SERVICE BULLETIN

NUMBER: 12-299-20R
DATE: 09/04/2020
REVISED: **09/28/2023**

SUBJECT: 6/8-way and Driver's Seat Hinge Cover-Design Change

Enlarged View of Damaged Claw

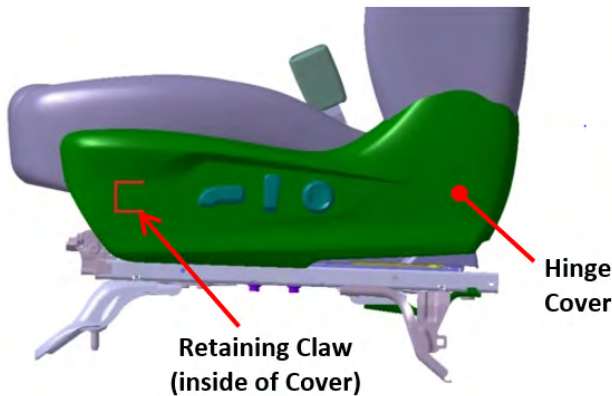
This bulletin announces a design change made to the outer hinge cover on the driver's 10-way adjustable power seats. The change has been made to address several reports about the cover coming loose over time as a result of getting into and out of the driver's seat. The retaining claw portion securing the cover to the seat frame has been changed to improve its strength and durability.
